| Clutches | Concentric Slave Cylinder | Anaerobic Sealer | Ford

## Anaerobic sealer required when replacing Concentric slave cylinder

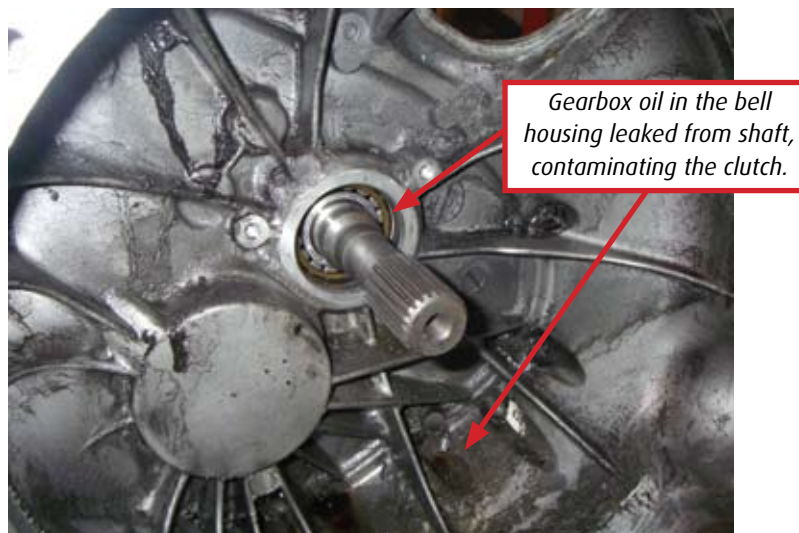
When replacing the concentric slave cylinder (CSC) 804508 on Ford vehicles fitted with a MTX-75 (5 speed) gearbox an anaerobic sealer is needed between the CSC and gearbox bell housing to prevent gearbox oil leaking along the shaft.

If this sealer is not added, gearbox oil will contaminate the clutch, causing clutch slip and a clutch replacement will be necessary.

The picture below shows a gearbox bell housing that did not have the appropriate sealer added when the CSC was replaced.

Ford produce and sell an anaerobic sealer, this can be supplied from Ford with part number ESK-M4G269-A. An alternative to this part number can also be used.

This sealer needs to be added onto the rear of 804508 where the CSC is in contact with the bell housing and sufficient amount is added to ensure complete sealing.
